Pulaski County Schools
Energy Savings and Performance Contract
Addendum #2
March 25th, 2022

CMTA Contact:	Megan Brangers
Email:	MBrangers@cmta.com
Cell Phone:	502-919-1521

The following information supersedes or is in addition to information released in the Contract Documents dated March 11th, 2022 and addendum 1 dated March 18th, 2022.

M1-
4.1

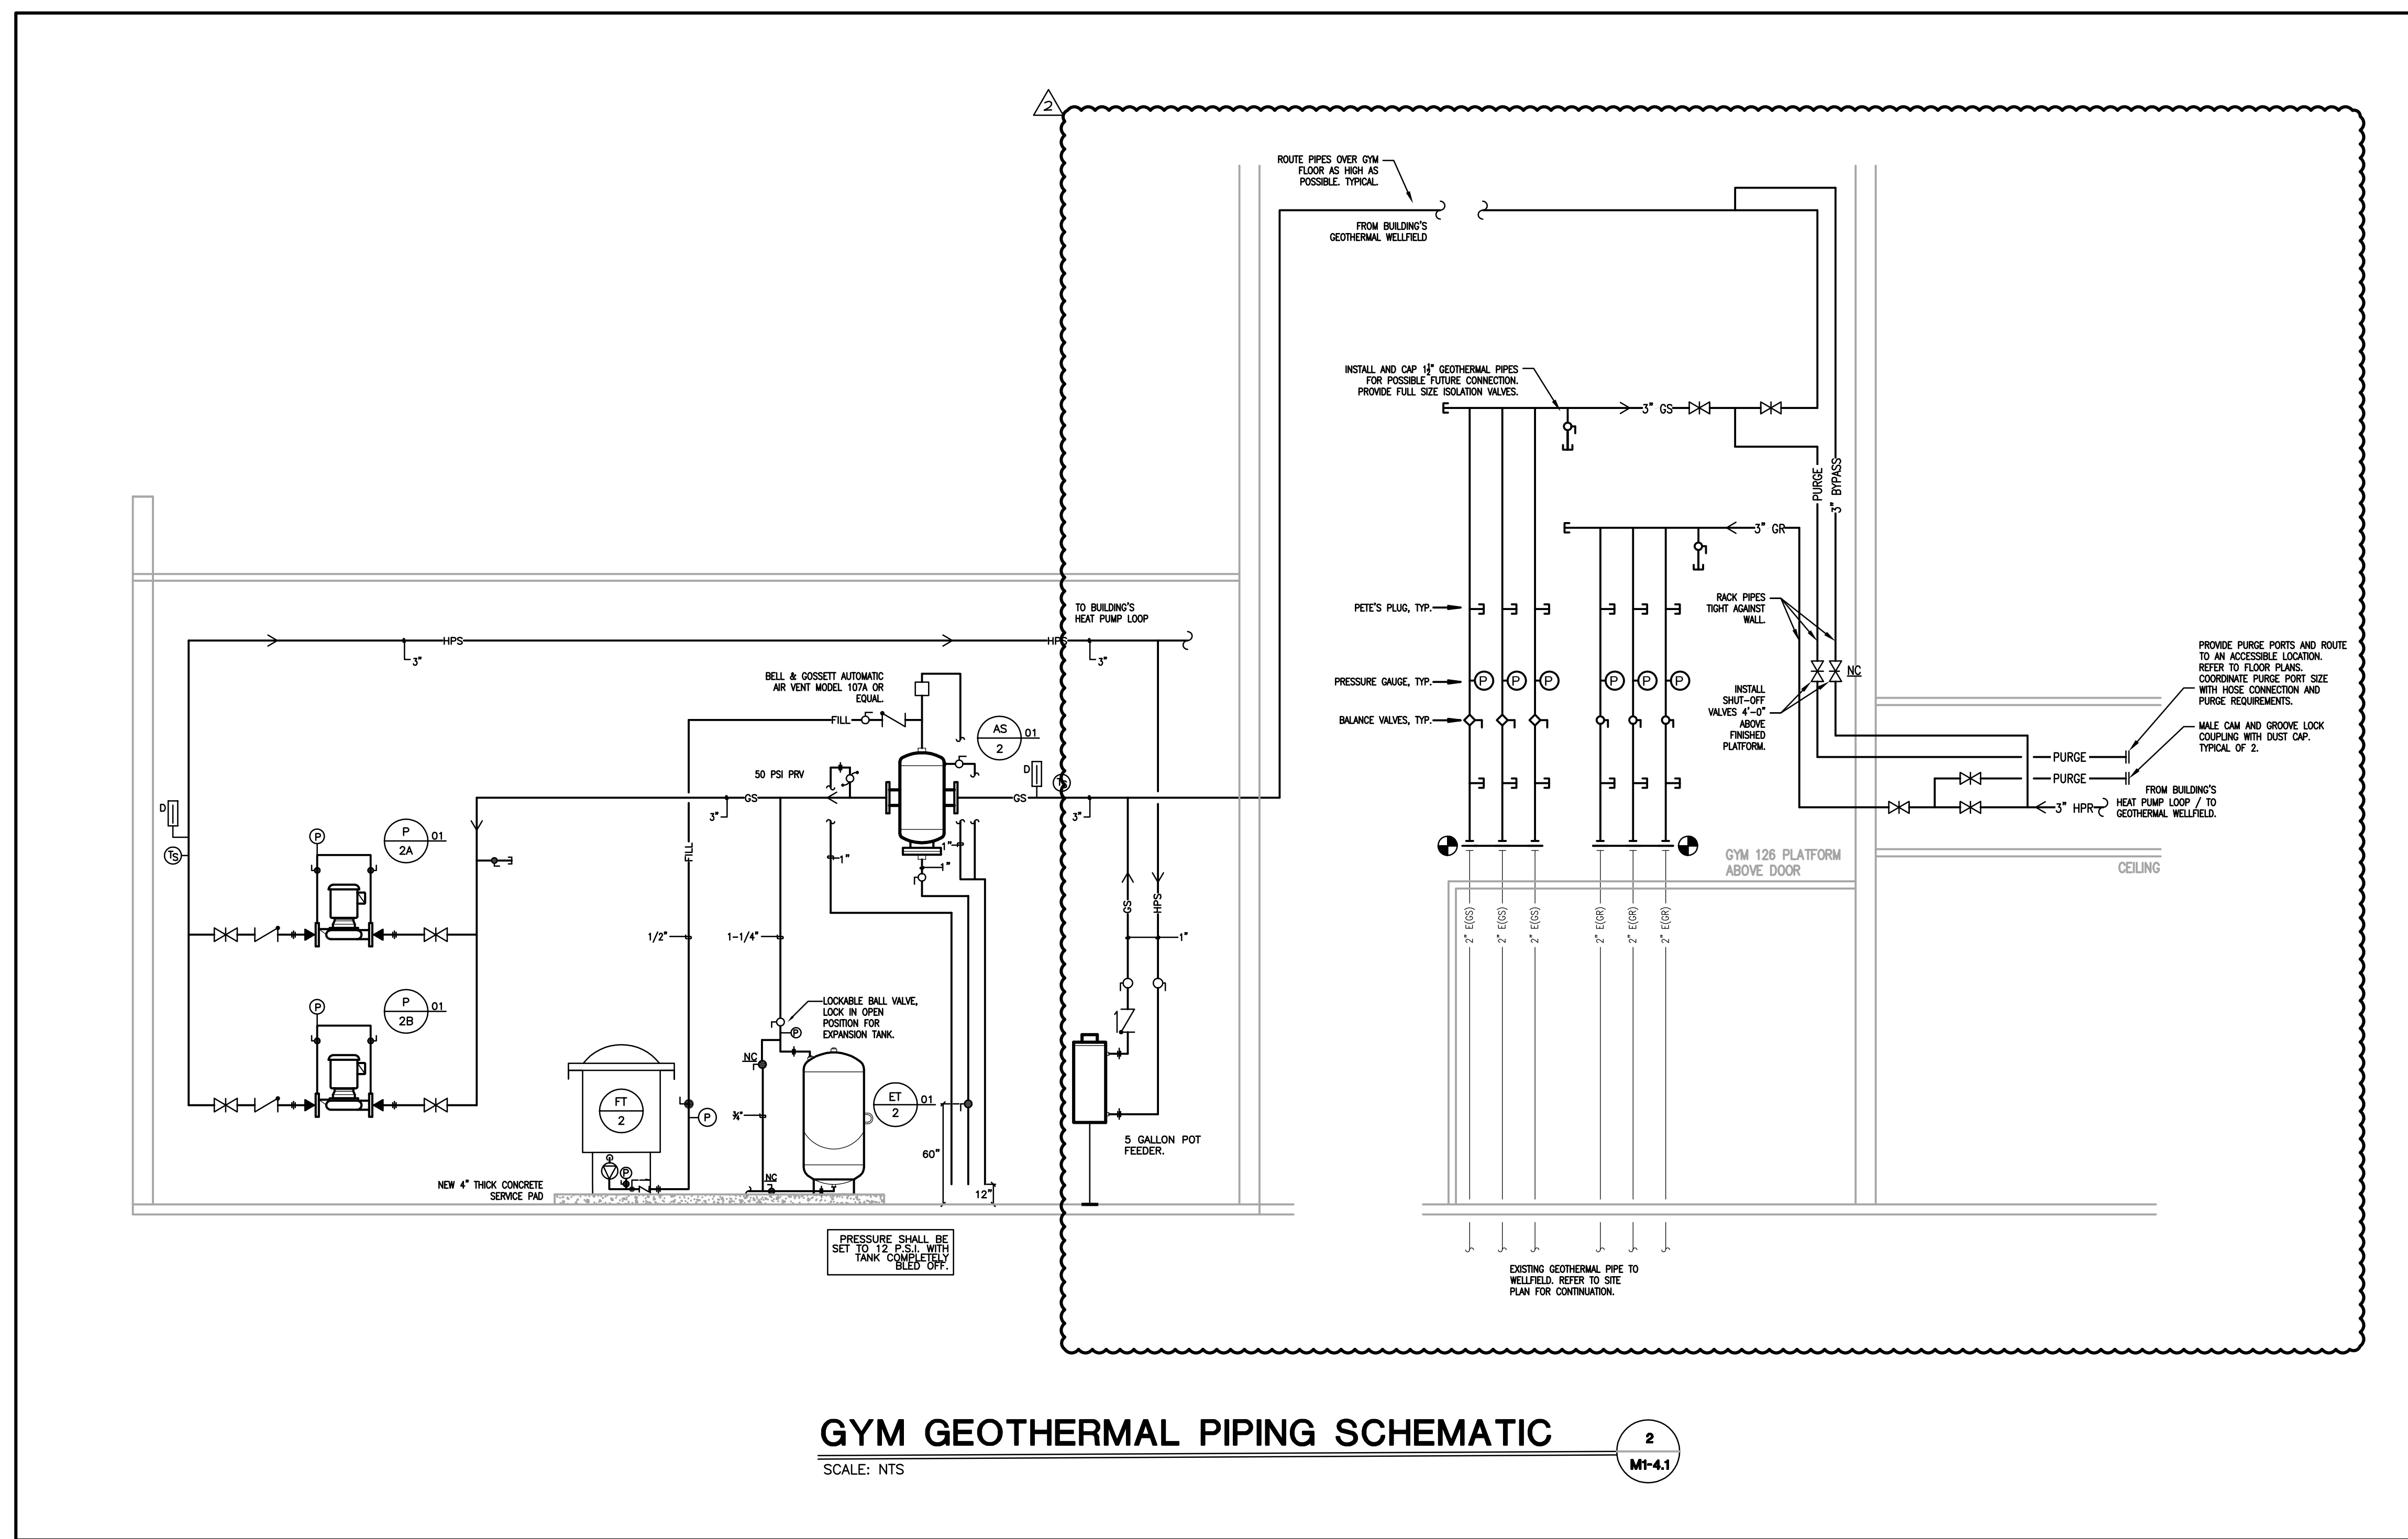
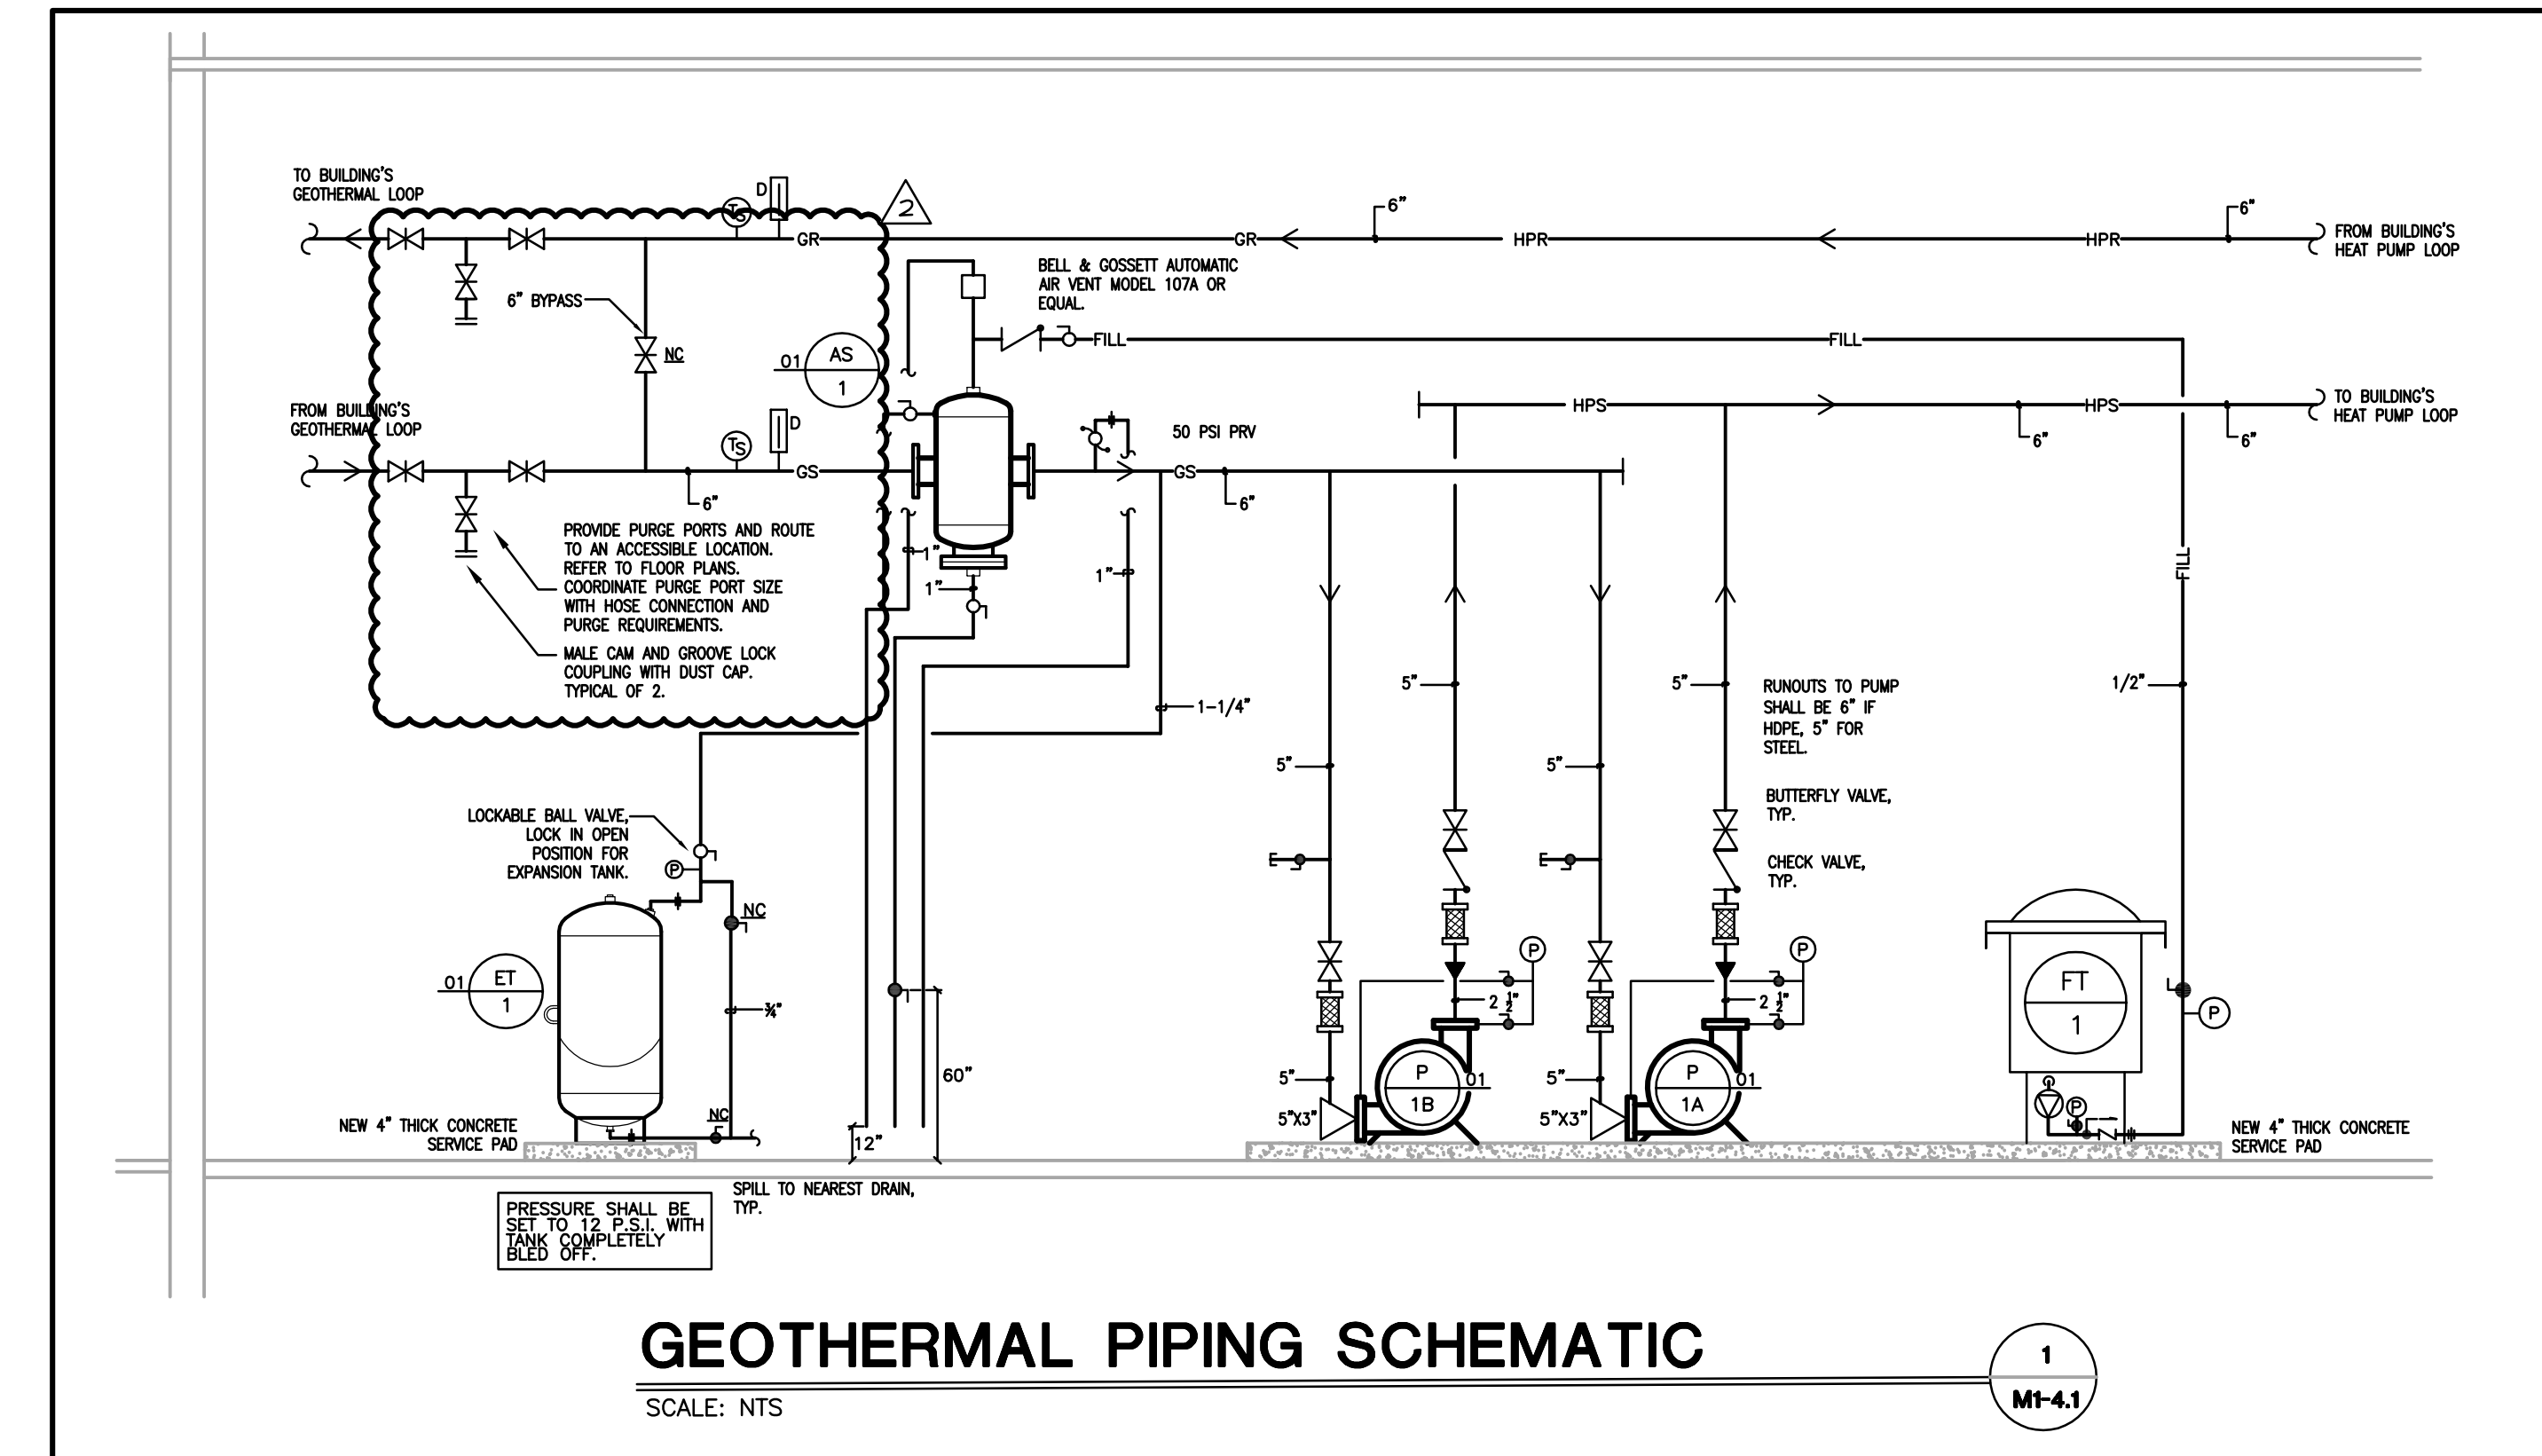
10. Drawing M1-4.1

- a. Refer to 'Geothermal Piping Schematic' for updates. Add geothermal wellfield bypass and purge ports.
- b. Refer to 'Gym Geothermal Piping Schematic' for updates. Add geothermal wellfield bypass and purge ports. Add 5-gallon pot feeder.
